CITY PLANNING COMMISSION

APPLICATION: A. Negative Declaration
 B. Rezone 5+ acres from Agriculture (A) to Garden Apartment Review (R-2BR)

LOCATION: West side of Greenhaven Drive, approx. 500 feet north of Pocket Road.

APPLC. NO. P84-277

EXHIBIT A
SITE PLAN

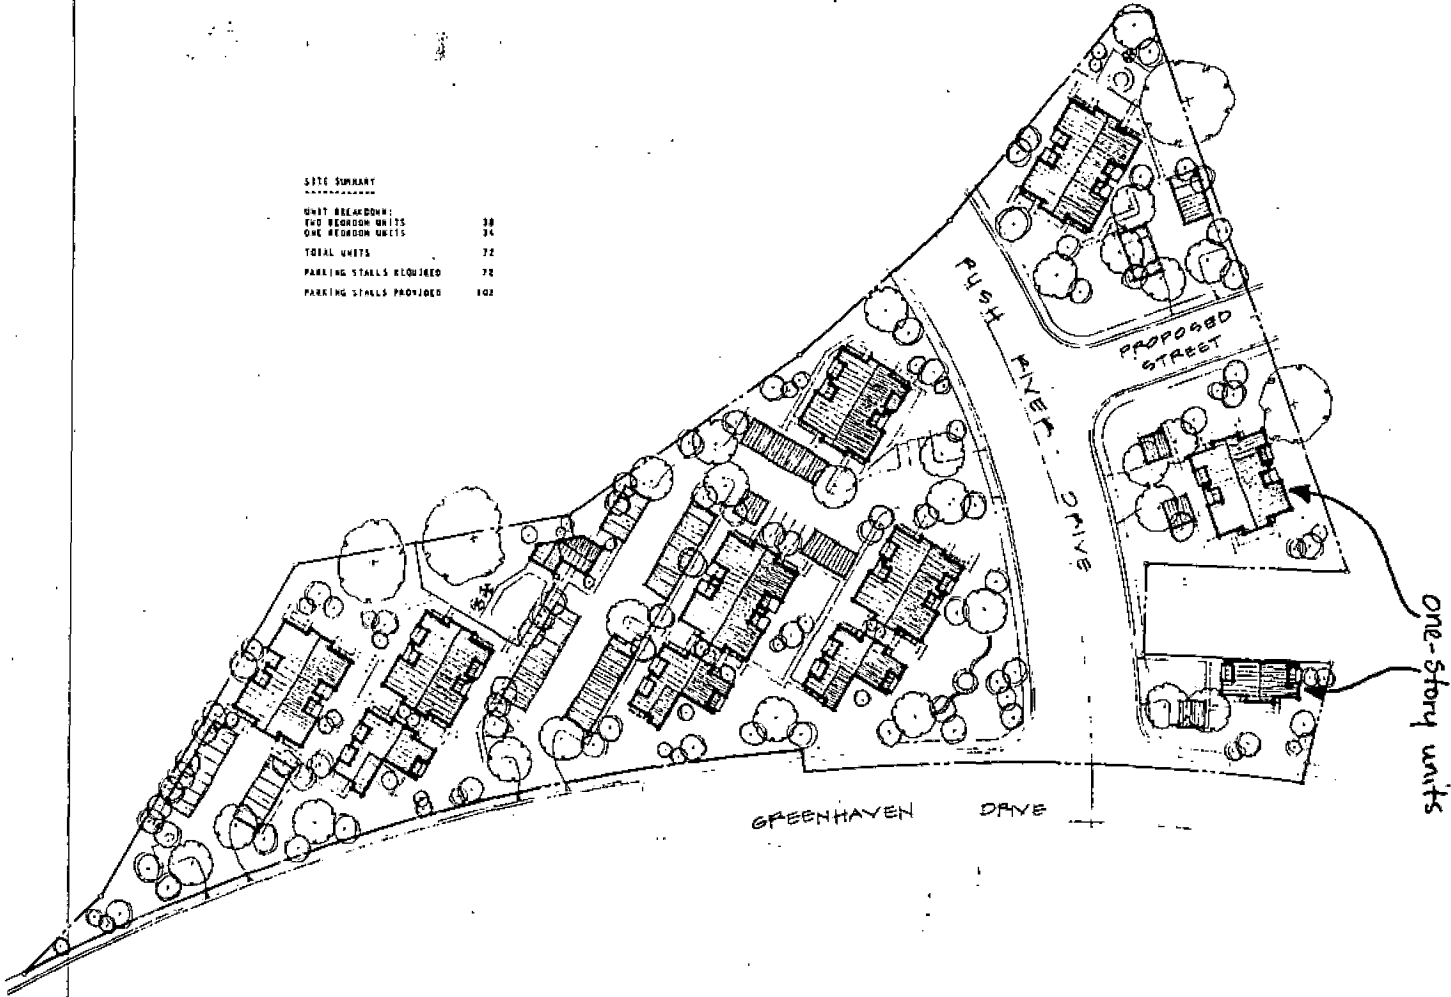
- B. The applicant proposes to develop 72 apartments units (density - 17.10 du/ac net). The units will be clustered in groups of 4 - 16 units per cluster. Each building will be two story (excluding the units indicated on Exhibit A which are one story) with units ranging in size from 624 sq. ft. (1 bdrm) to 840 sq. ft. (2 bdrm). The applicant will provide 120 parking spaces (both covered and uncovered). A recreation building and pool area will also be provided.

EXHIBIT C
ELEVATIONS

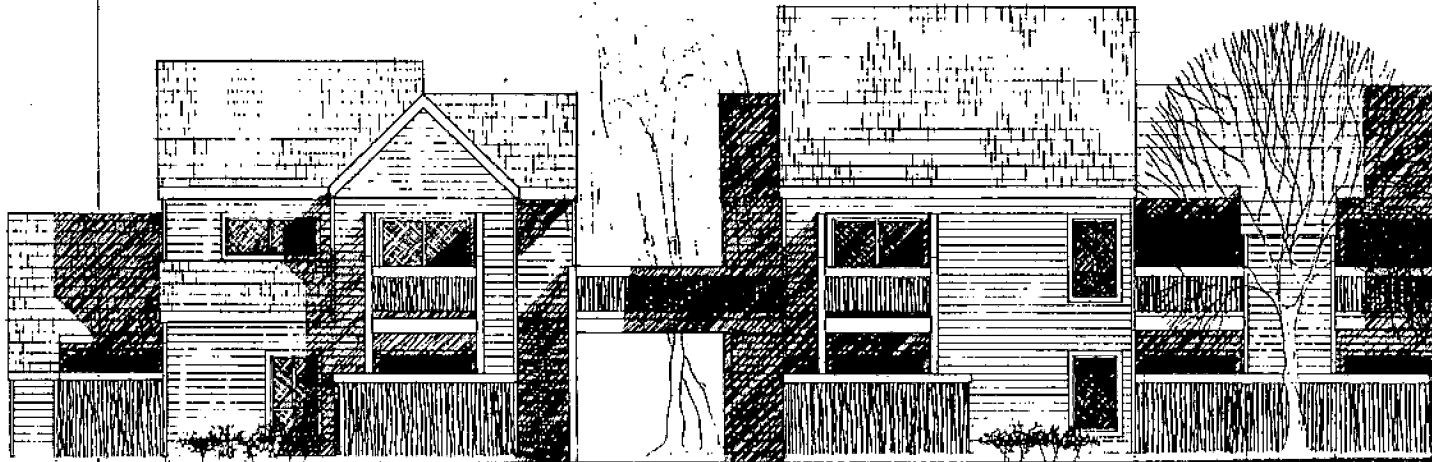
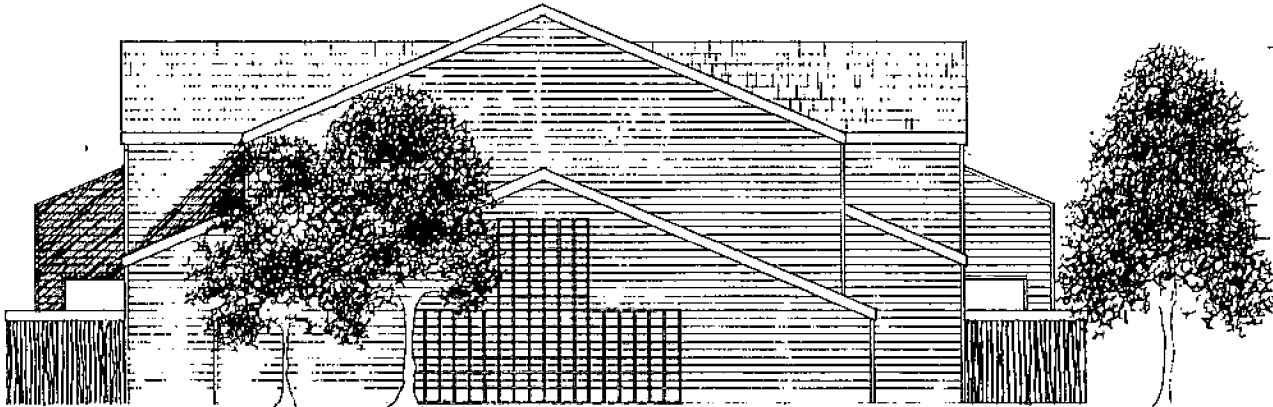
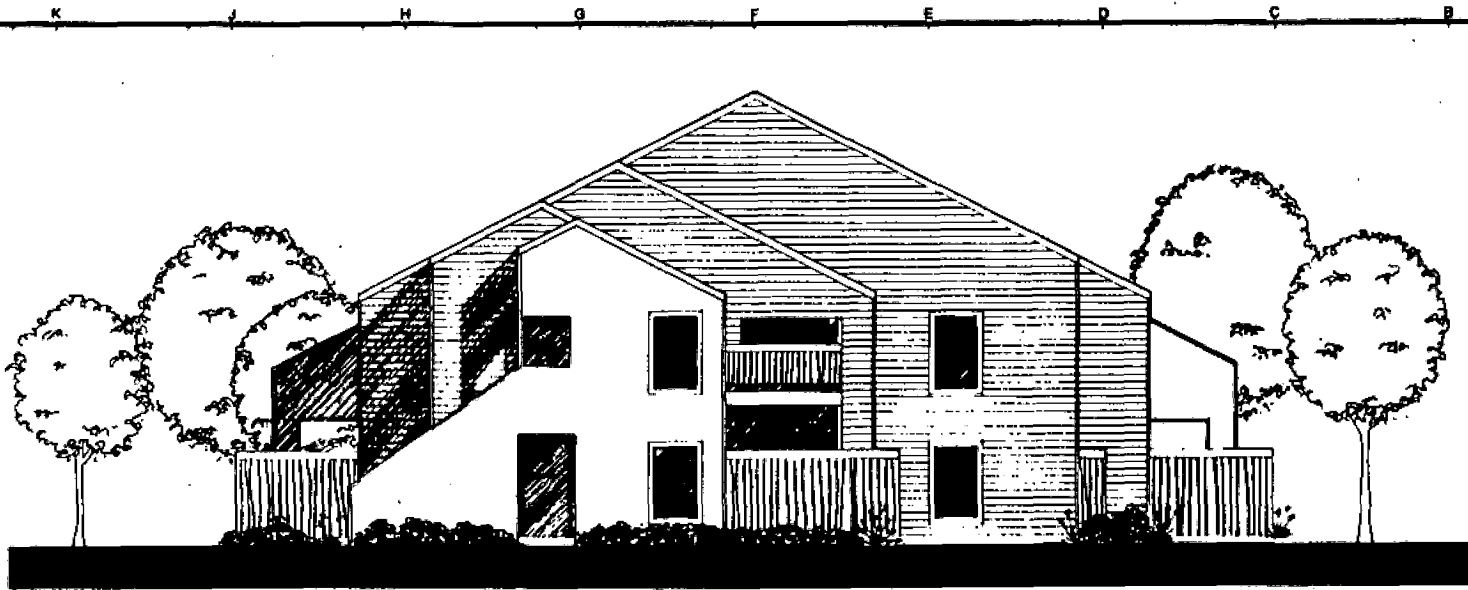
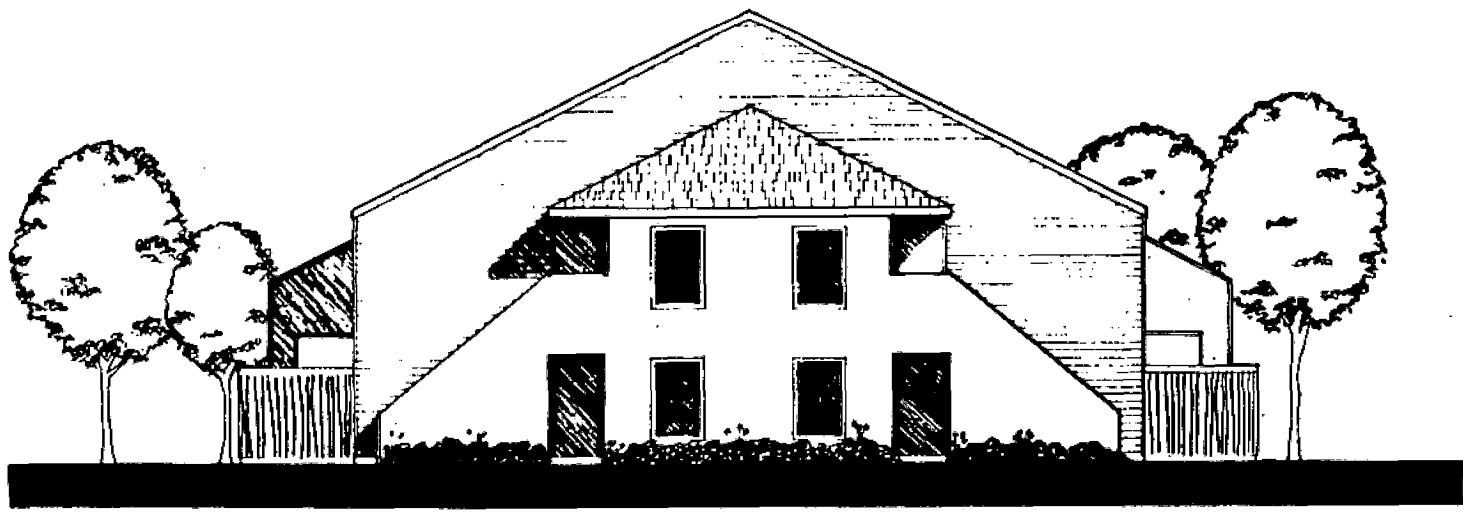
- C. The applicant proposes to use masonite lap siding on the exterior and wood shakes for the roof. Exterior colors will be earthtones. The proposed roof line and building elevations create a somewhat monotonous appearance to the eye. The building end elevations, which are devoid of windows, will create a visual barrier for both residents of the project as well as surrounding property owners and motorists. Staff has met with the applicant's architect to discuss concerns regarding the end elevations, carports and stairway construction. The applicant's architect has indicated that the plans submitted are conceptual and that the following changes will be incorporated to mitigate staff's concerns:

- 1. End elevations - Unit configuration to be modified to change architectural relief. Windows to be added to break up blank wall.
 - 2. Stairways - Stairs are proposed to be constructed of concrete steps with a single iron stringer support. These stairways tend to be unsightly; therefore, the applicant proposes to screen the stairway by partially enclosing them with siding to match the units.

1. The applicant shall submit revised site and elevation plans for review and approval by the Planning Director prior to the issuance of building permits. Revised plans shall include the following:
 - a. Carports shall be designed with material and color that are compatible with the building.
 - b. Stairways shall be screened from public streets with wood materials.
 - c. End elevations shall be modified to provide relief and interest.
